# Notice of Allowability

10/733,572

ROBINSON ET AL.

Fig. 2

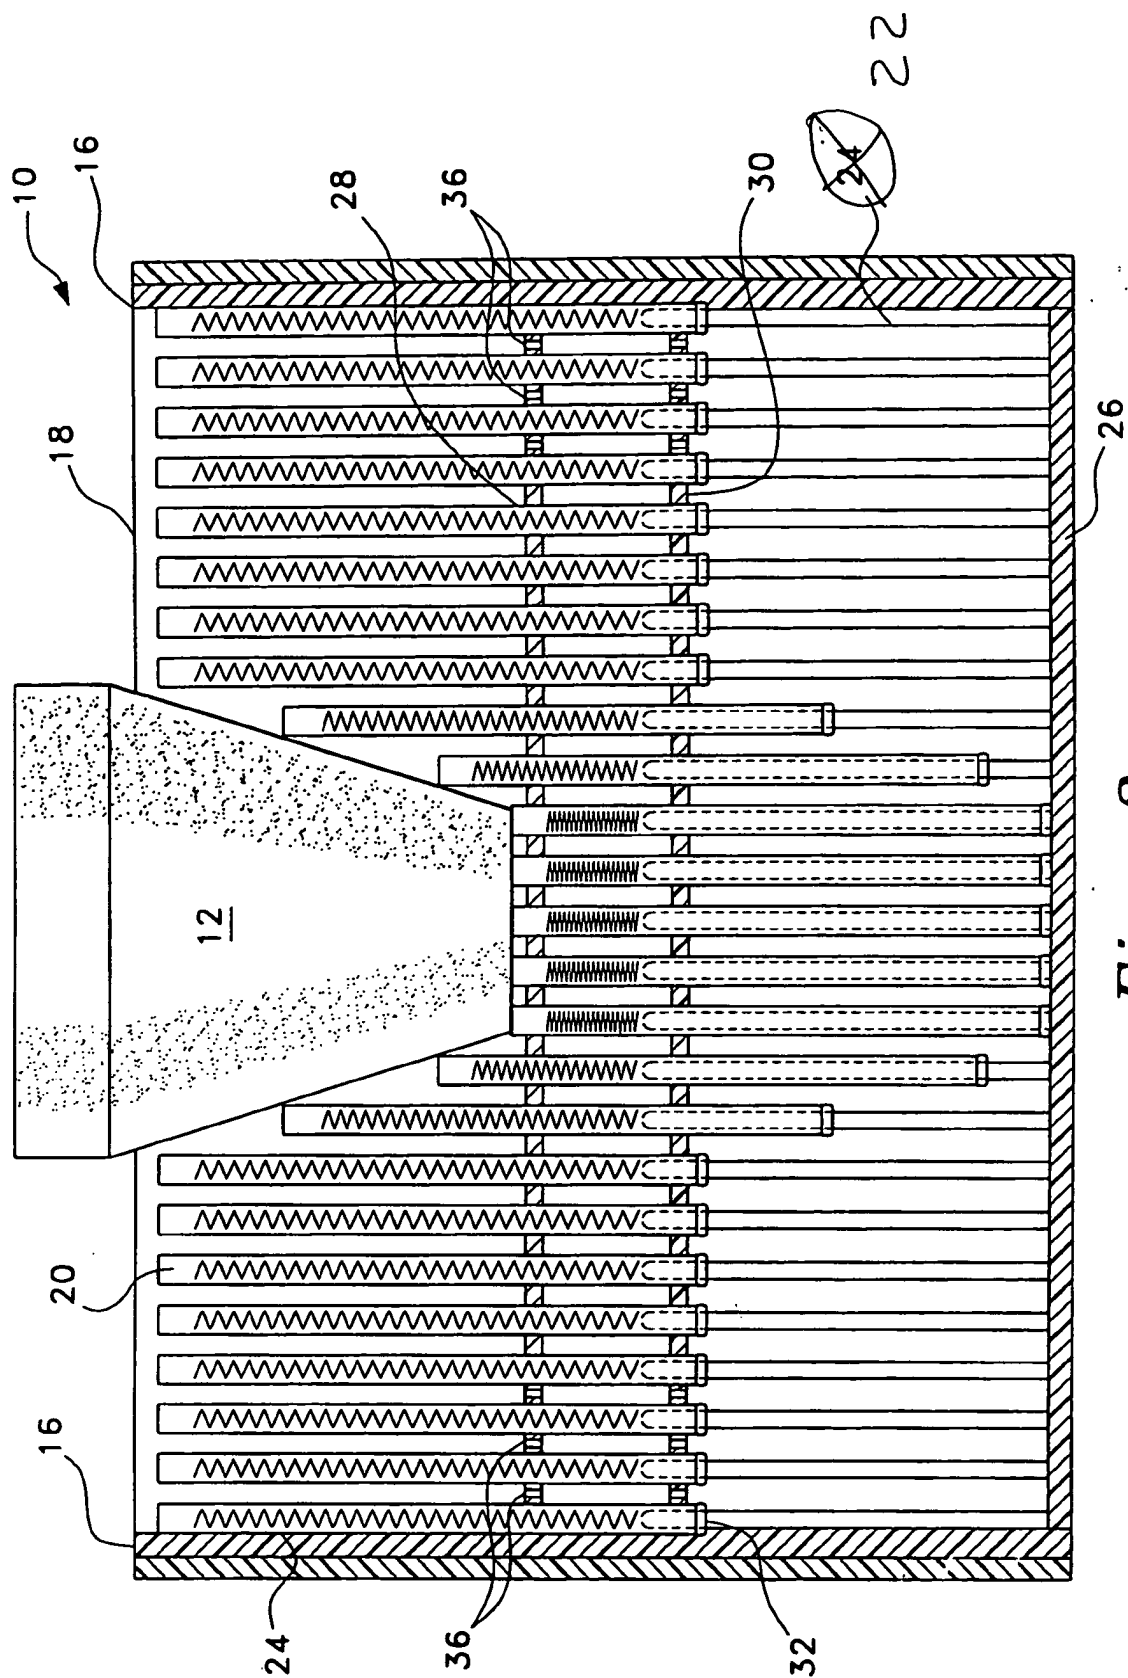
The following changes to the drawings have been approved by the examiner and  
agreed upon by applicant: in Fig 2, reference numeral "24" (lower left corner) has been  
changed to - - 22 - -.

In order to avoid abandonment of the application, applicant must make these above agreed upon drawing changes.
